**PARK CITY REGULAR PLANNING COMMISSION MEETING
SUMMIT COUNTY, UTAH
September 29, 2021**

Planning Commission Staff Report

Subject: Park City Mountain Base Area Development
Project #: PL-20-04475
Authors: Alexandra Ananth – Senior Planner
Date: September 29, 2021
Type of Item: MPD Modification

[Exhibit A: Applicant's Open Space Calculations](#)

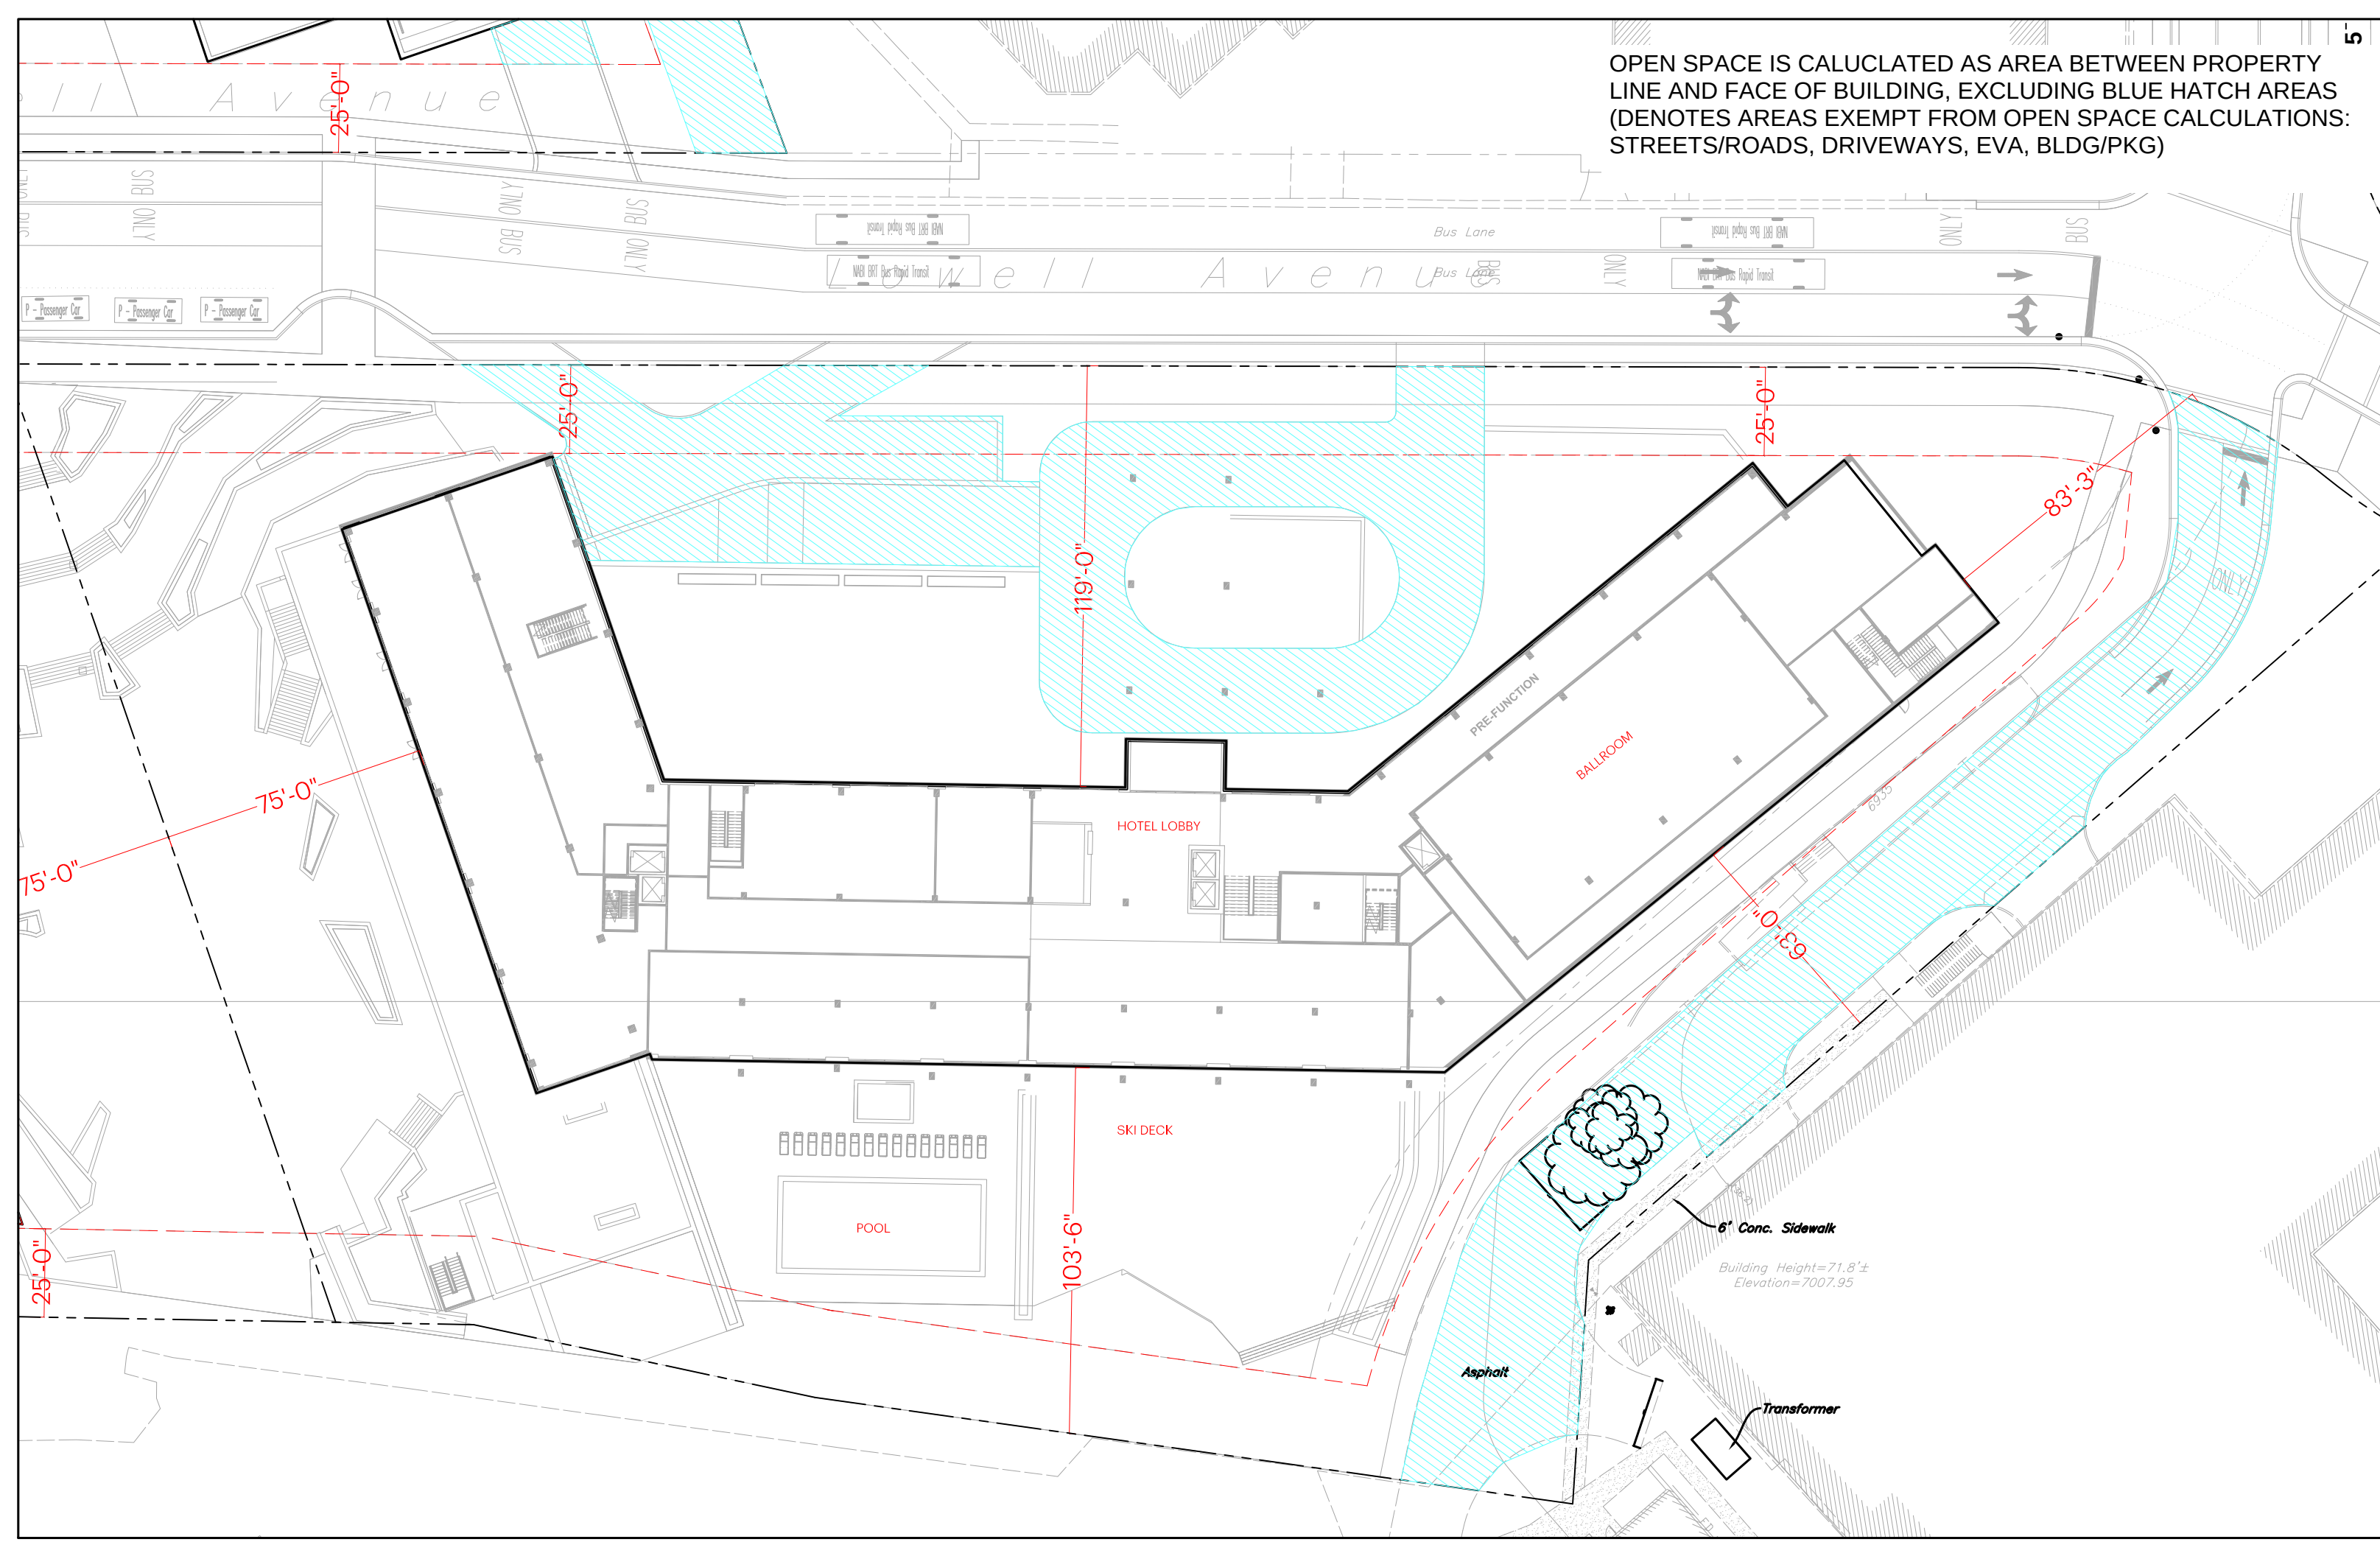
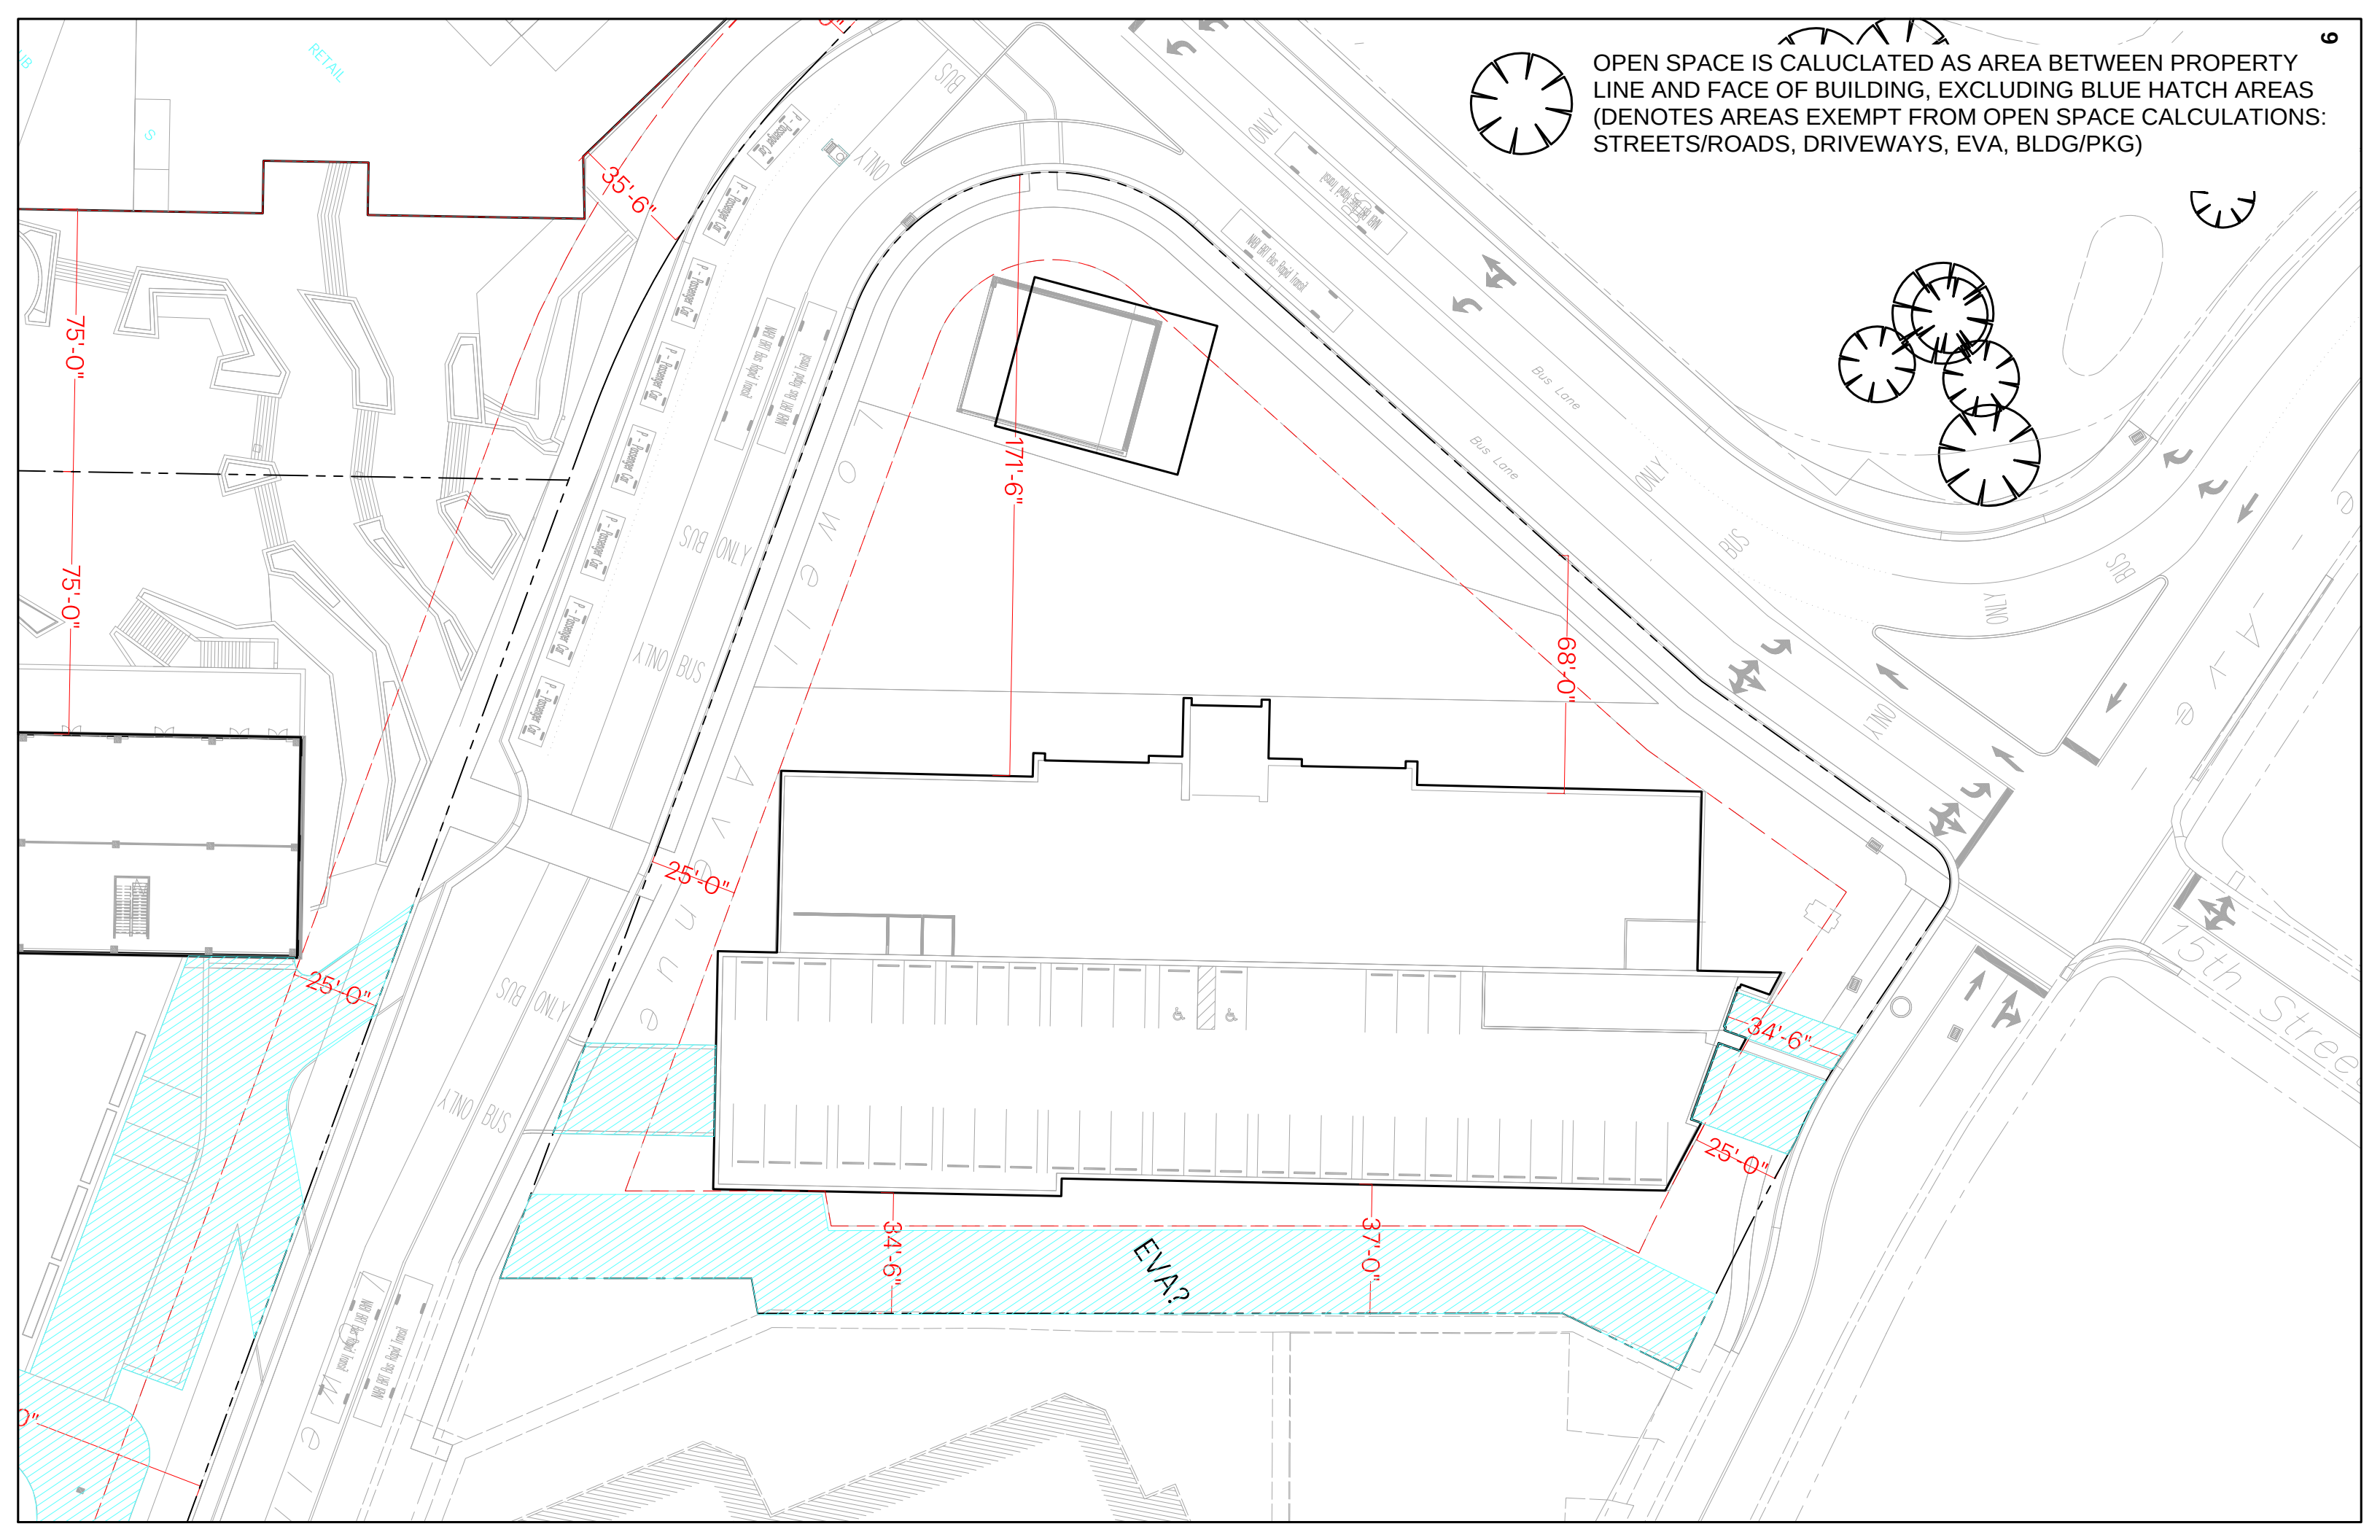
- FOF #38 - is Resort Core defined? If not delete. ***Deleted.*** Commissioner Suesser does not believe sufficient back up has been shown for this calculation. How does helipad factor in? ***The applicant resubmitted their Open Space calculations (Exhibit A). This calculation includes the 1998 Exhibit A Open Space area on the mountain, excludes all of Parcel A, and includes the paseo on Parcel B. The applicant should clarify if the ski beach and pool deck on Parcel C are open to the public and included in the Open Space calculation. Amenities open to the public may be included, but amenities that are private to hotel guests only cannot be included as Open Space. It is still not clear where the helipad will be located and if this will count against calculated Open Space.***
